**Title: LIMITED CYLINDER EXCHANGE**

Issued: **07/12/04**

Mandatory Service Bulletin No. 04-8

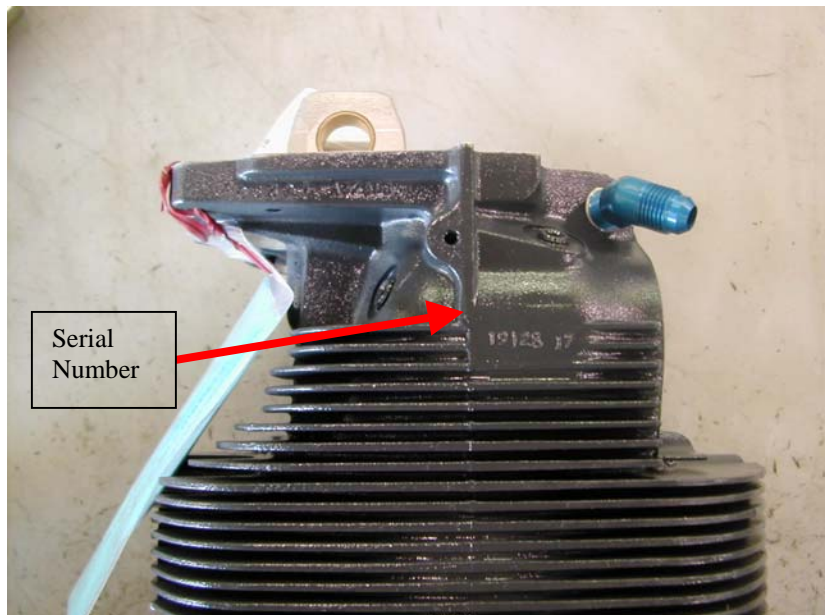
**4.2** Verify which cylinder(s) have one of the serial numbers listed in paragraph 2.0 above. The cylinder serial number can be found on a flat on the outside of the intake port as shown in the photograph at right.
